HISTORIC AND DESIGN REVIEW COMMISSION

Agenda Item No: 15

HDRC CASE NO: 2016-123
ADDRESS: 208 BUSHNELL
LEGAL DESCRIPTION: NCB 6328 BLK 1 LOT 17, E 11.2 FT OF 16 & W 38.8 FT OF 18
ZONING: R5 H
CITY COUNCIL DIST.: 1
DISTRICT: Monte Vista Historic District
APPLICANT: Ramon Torres/Turn Key Pros
OWNER: Rodolfo Vaglienty
TYPE OF WORK: Construction of a rear carport
REQUEST:

PROPOSED CARPORT-AERIAL VIEW

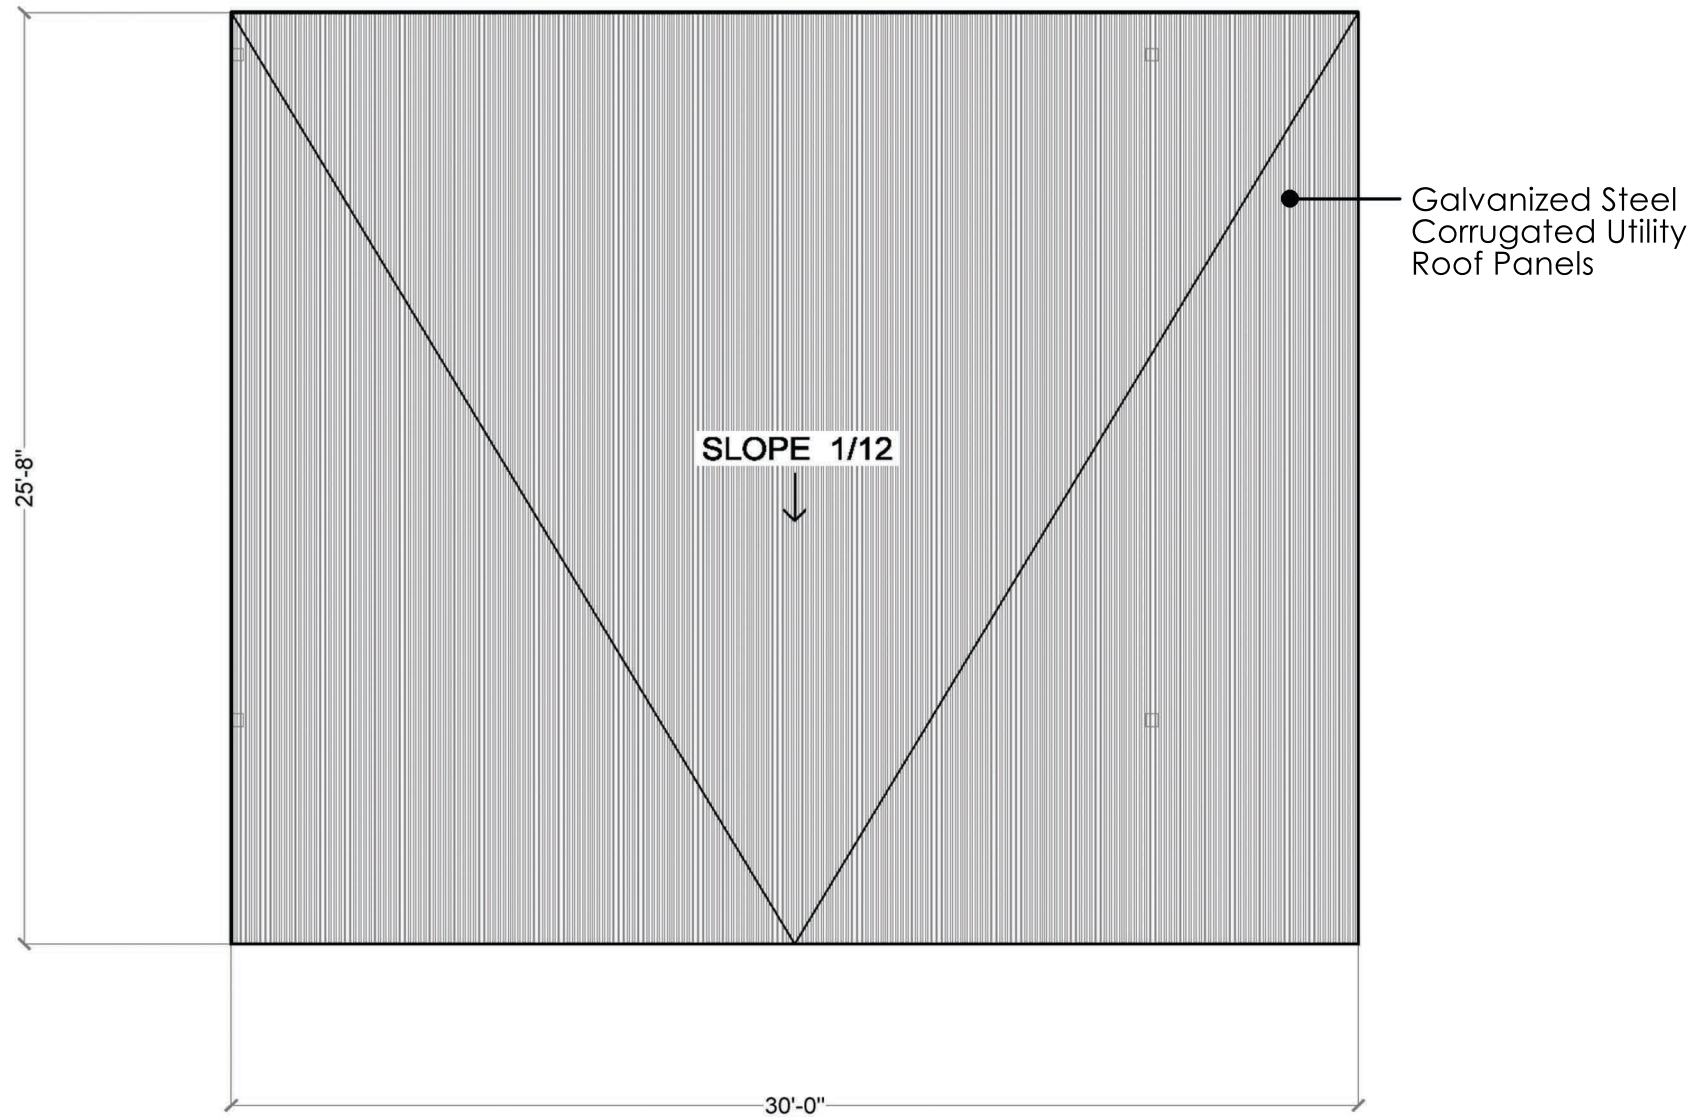
- d. In regards to site location, the applicant has proposed to site the accessory structure at the rear of the property along the side and rear property lines. The location at the rear of the property is appropriate, however, the applicant should ensure that there is a three foot setback between the structure and property line.

CARPORT ELEVATIONS

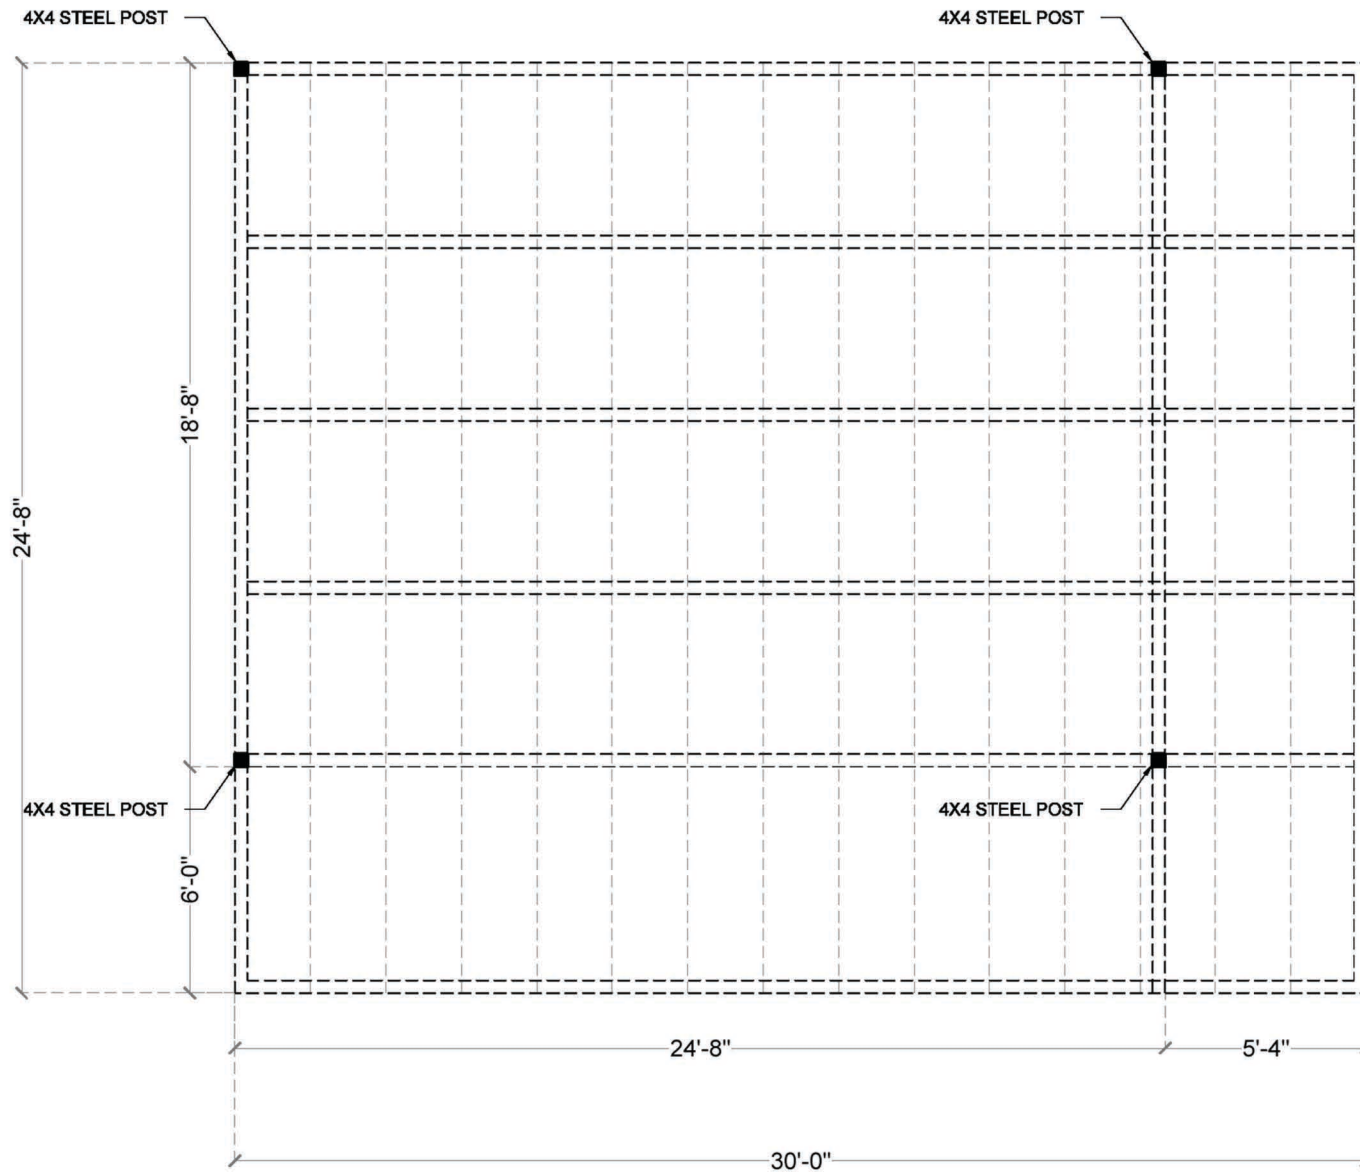
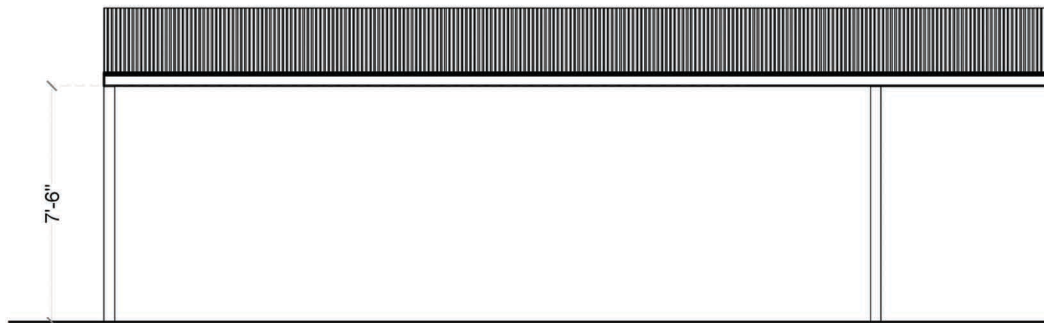
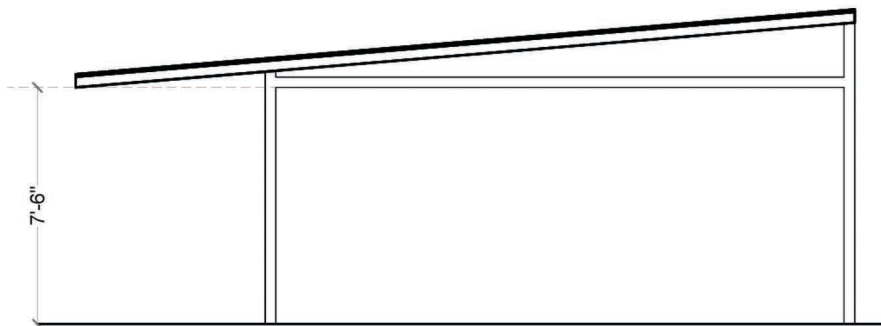
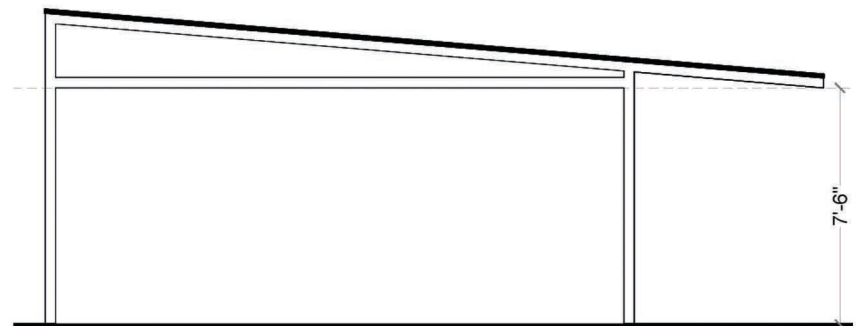
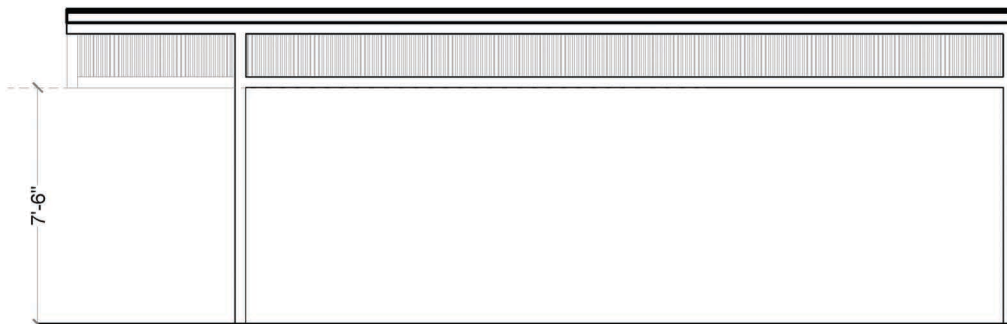
- c. The applicant has proposed materials to include 4" x 4" steel columns and galvanized steel corrugated utility panels for the roofing material. The primary historic structure at 208 Bushnell is of the Spanish Eclectic

architectural style. Additionally, there is an existing accessory structure that features a stucco exterior. Staff finds that the applicant's proposed materials are not architecturally appropriate for the style of the primary historic structure nor the Monte Vista Historic District. Staff finds that materials such as cedar posts and tile-like roofing would be more appropriate.

Staff does not recommend approval based on finding c. Staff finds that materials consisting of cedar posts and a tile-like roof would be appropriate.
